Kistler Instruments SITE PLAN 10-44

PLAN REVIEW CENTER REPORT

SP10-44

Preliminary Site Plan

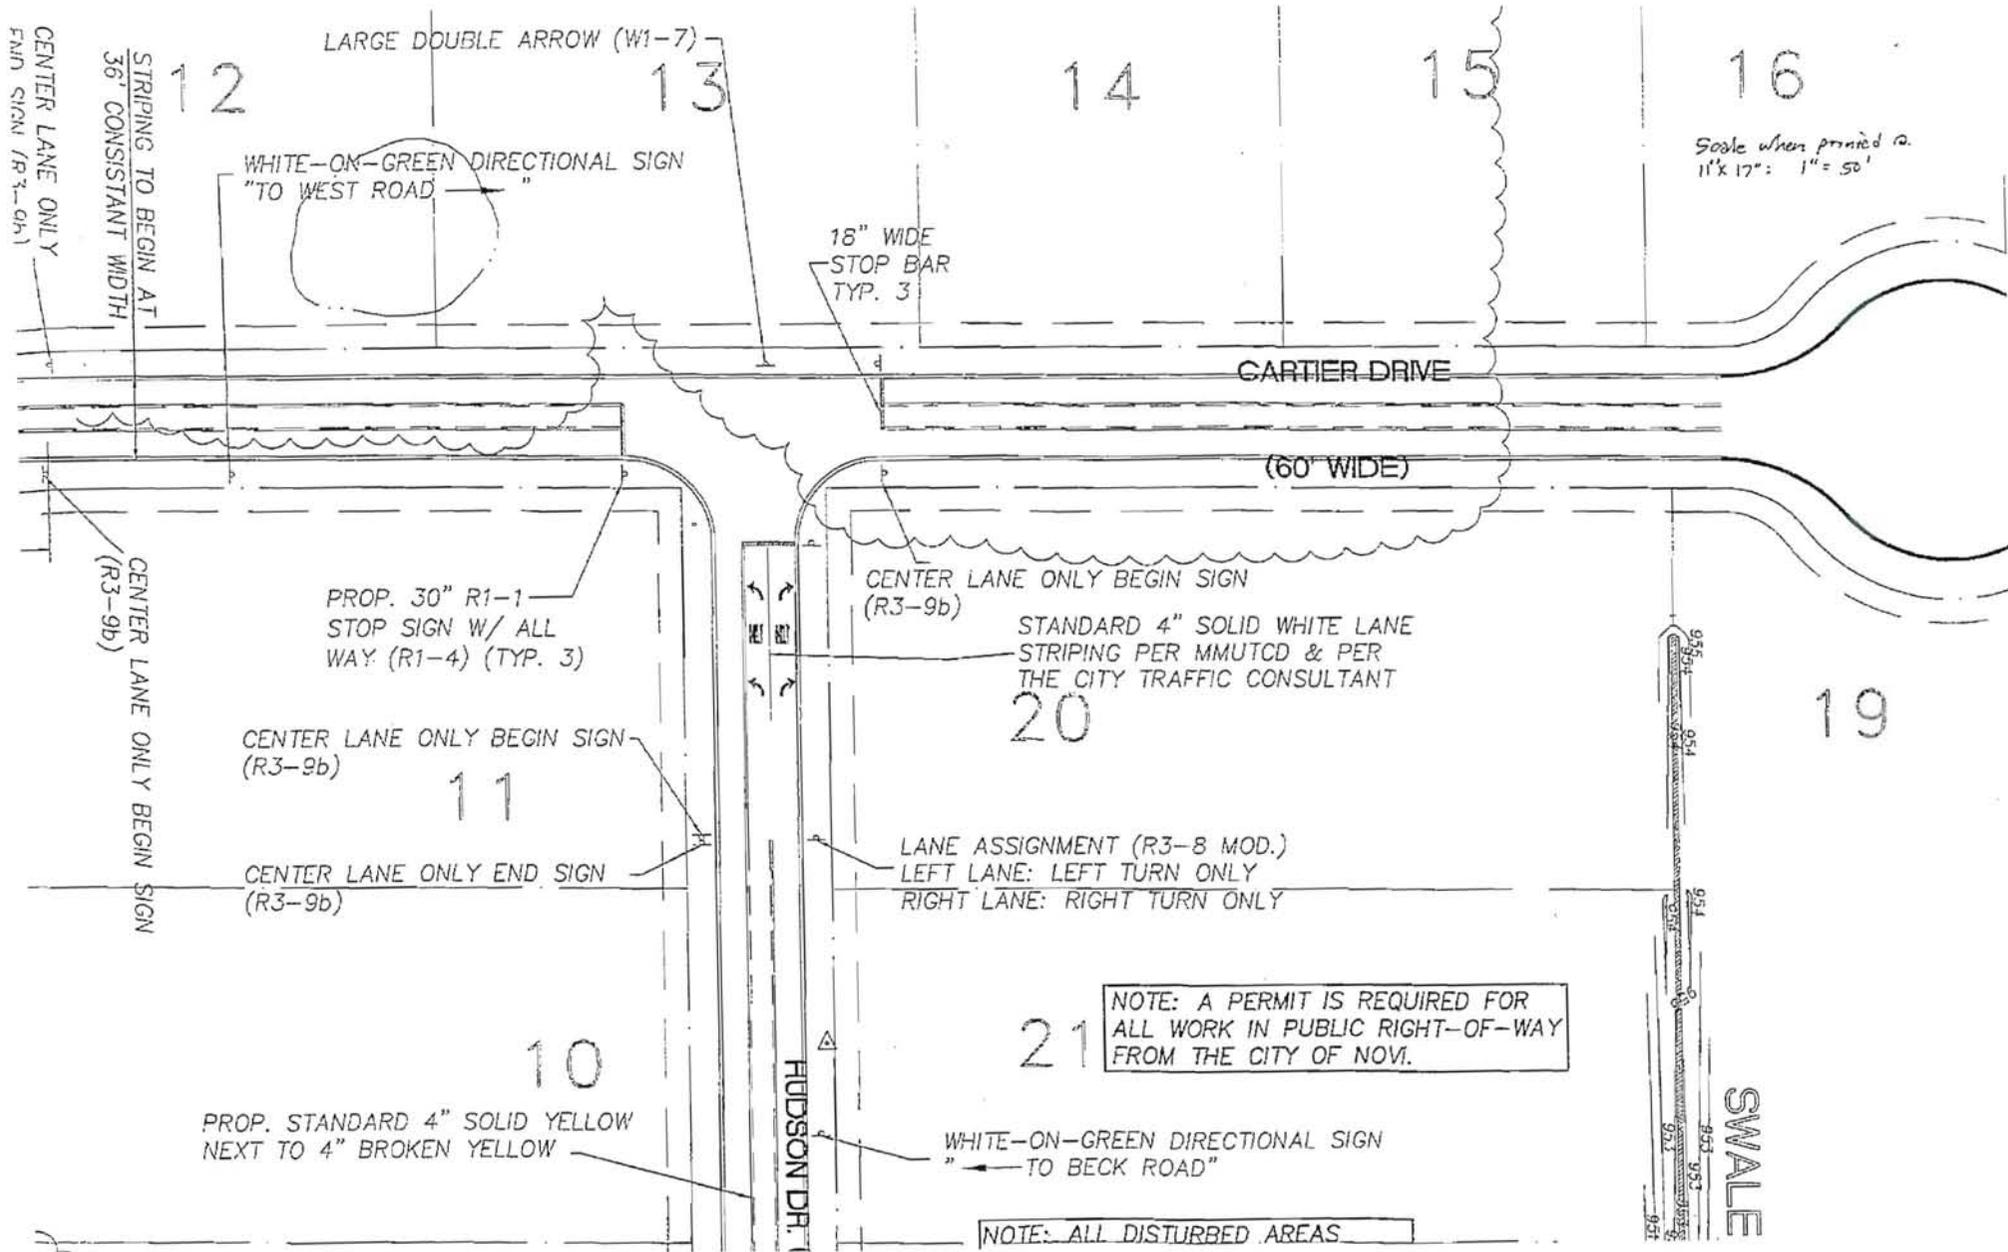
4. No. We do recommend, however, that the City consider striping the two-way left-turn lane on Hudson and Cartier Drives, as called for in the previously approved plans for the overall park (see attached excerpt of those plans).
